AVENGER DASH LIGHT FOAM SERVICE BULLETIN	UP 070 REV 0 2010-12-08
		Page 1 of 1

AMBULANCE TYPE: MX151D 2009

TITLE : DASH AVENGER LIGHT MODIFICATION			
DATE : 2010-12-14	DRAW. : Y. DUBÉ B. LANDRY	# DRAWING : # 00690	REV : 0
# ASS :			PAGE : 1/1

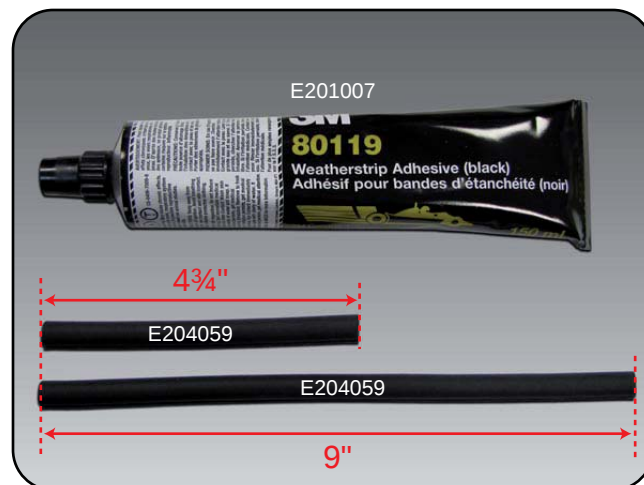
This bulletin is to inform owners of Demers Ambulances that a replacement of the Foam around the avenger dash light is required. The foam does not stick properly on the light creating reflection light into the windshield.

- 1 - Remove Avenger light on the windshield.
- 2 - Clean the surface (windshield).
- 3 - Remove the Neoprene (sealing joint) on the Avenger light and clean the surface.

- 4 - Make sure you have the needed item :
Weatherstrip Adhesive (not supplied)
Sealing joint (supplied)

- 5 - Apply adhesive as shown.
Let Dry 10 Minutes

- 6 - Install sealing joint all around as shown.

- 7 - Apply adhesive in corners.
Let dry 10 minutes
- 8 - Then press two joint strips together.

- 9 - The modification is done
Let dry 30 minutes
- 10 - Reinstall the Avenger light in the vehicle.
